Project Name: Klinefelter - SFD
Project Location: 8469 East Spring Park
Eden, UT

PLAN REVIEW COMMENTS:

- S1. S0.1:
 - A. Concrete, Footings, Note 2: The frost depth is 42” per Geotech report. The note indicates 30 in. Please verify and revise. (Geo report)
- S2. S0.5:
 - A. Steel Column Schedule: SC-2 detail information appears missing. Please verify and provide. (IBC 107)

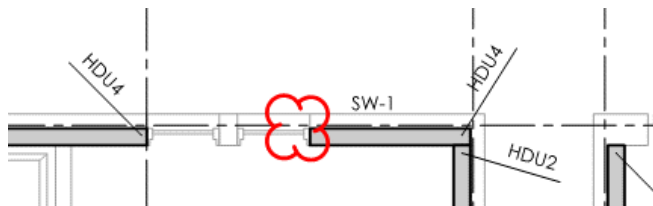
- B. Many of the section call outs are incomplete or illegible. This applies on other sheets as well. Please verify and revise. (IBC 107)

S4. S3.1:

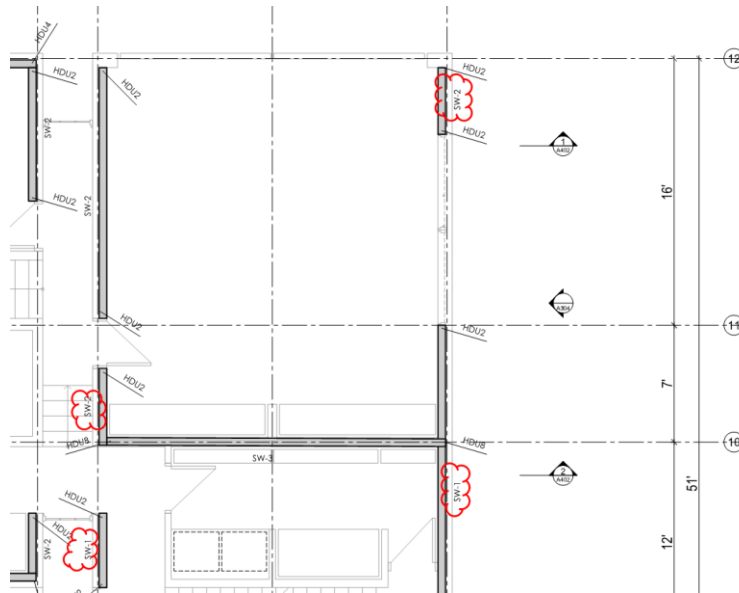
- A. The structure appears to have horizontal nonparallel system irregularity. Please verify that the requirements of ASCE 7 T12.3-1 are satisfied.
- B. GL-12, B: The shear wall has hold down only on one side. Typically, two are required. Please verify if both ends of the shear walls require hold downs. Please verify all locations. (IBC 1609, 1613)

- C. Shear wall schedule shows SW-2 has 4" edge nailing. It shows SW-3 has 3" edge nailing. The sill bolt appears to be smaller at the higher capacity shear walls. Please verify if the anchor bolt should be larger. (IBC 1609, 1613)

- D. Shear walls on the same line appear to vary. The seismic design story shear is distributed based on relative lateral stiffness for shear walls along the same line. Please verify that this has been considered. (ASCE 7 12.8.4, AWC SDPWS 4.3.3.4)

S5. S3.2:

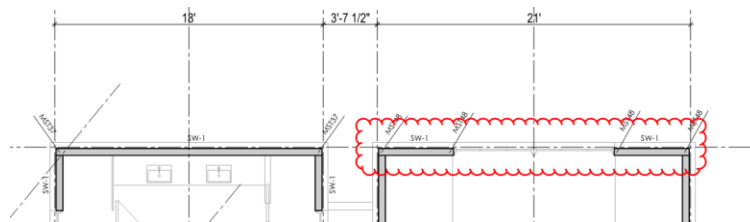
- A. The structure appears to have vertical in-plane discontinuity irregularity. Please verify that the increase load requirements of ASCE 7 12.3.3.3, 12.3.3.4 have been satisfied. (ASCE 7 T12.3-1)

S6. S4.1:

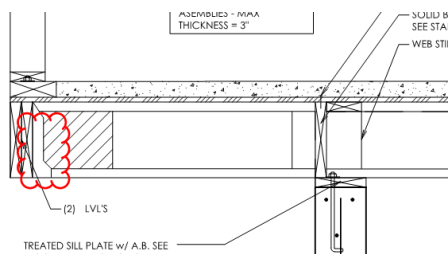
- A. Detail 10: Please verify if hanger is upside down for the cantilever application. (IBC 1604)

B. Detail 4, 5, 8, 9:

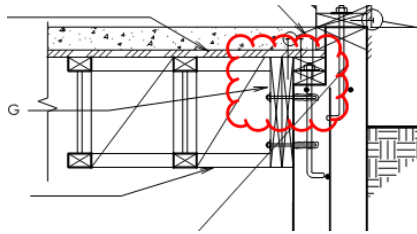
- I. Anchor bolts are shown epoxied into the concrete foundation wall. Information for type, embed depth, spacing, brand of epoxy, edge distance...etc are not obvious on the drawing. Please verify and provide. (IBC 107)
- II. The edge distance appear to be very close to the edge. This may be ineffective. Please verify and provide adequate edge distance. (IBC 1604)

B. Detail 4:

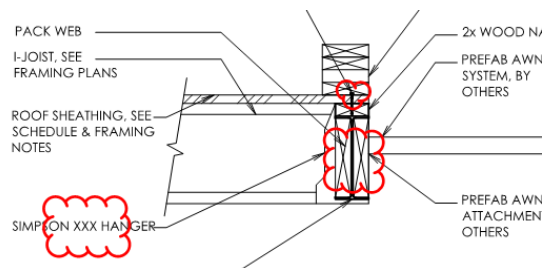
I. Simpson hanger has not been identified. Please verify and provide hanger information for all details. (IBC 107)

II. Please clarify connection of wood to steel beam. Connection information is not obvious on the plans. (IBC 107)
